UNITED STATES
DEPARTMENT OF THE INTERIOR
BUREAU OF LAND MANAGEMENTFORM APPROVED
OMB NO. 1004-0137
Expires: January 31, 2018**SUNDRY NOTICES AND REPORTS ON WELLS**
*Do not use this form for proposals to drill or to re-enter an abandoned well. Use form 3160-3 (APD) for such proposals.*5. Lease Serial No.
NMSF079043

PLUG AND ABANDONMENT PROCEDURE

NEBU 340

Re: Permanent Abandonment
Well: NEBU 340

Proposed P&A

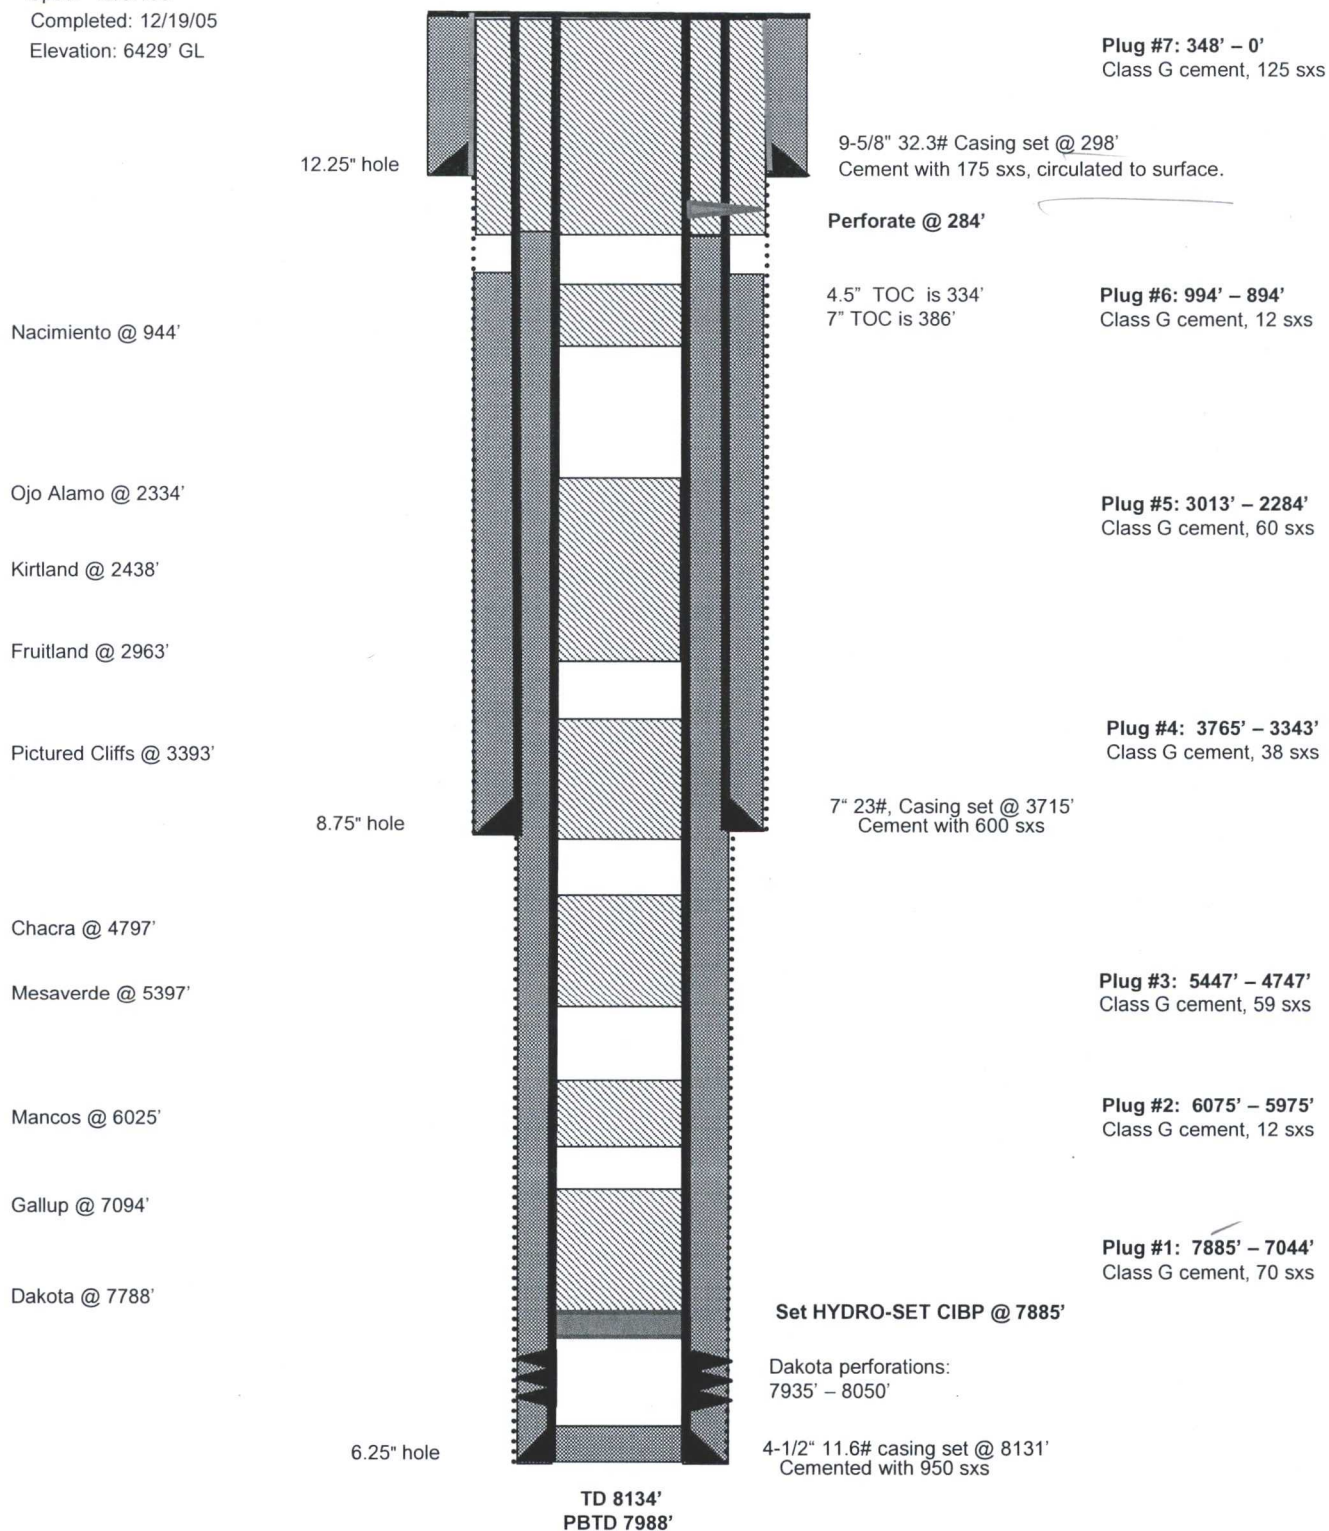
3. The following modifications to your plugging program are to be made:
 - a) Set Plug 1 (7885 – 6751) ft. to cover the Graneros and Gallup tops. BLM picks top of Graneros at 7714 ft. BLM picks top of Gallup at 6801 ft.

- b) Set Plug 2 (6186 – 6086) ft. to cover the Mancos top. BLM picks top of Mancos at 6136 ft.
 - c) Set Plug 3 (4163 – 4063) ft. to cover the Chacra top. BLM picks top of Chacra at 4113 ft.

- d) Set Plug 4 (3402 – 3302) ft. to cover the Pictured Cliffs top. BLM picks top of Pictured Cliffs at 3352 ft.
 - e) Set Plug 5 (2989 – 2192) ft. to cover the Fruitland and Ojo Alamo tops. BLM picks top of Fruitland at 2939 ft. BLM picks top of Ojo Alamo at 2242 ft.

- f) Set Plug 6 (755 – 655) ft. to cover the Nacimiento top. BLM picks top of Nacimiento at 705 ft.

Operator must run a CBL to verify cement top. Submit the electronic copy of the log for verification to the following addresses: jwsavage@blm.gov Brandon.Powell@state.nm.us

You are also required to place cement excesses per 4.2 and 4.4 of the attached General Requirements.
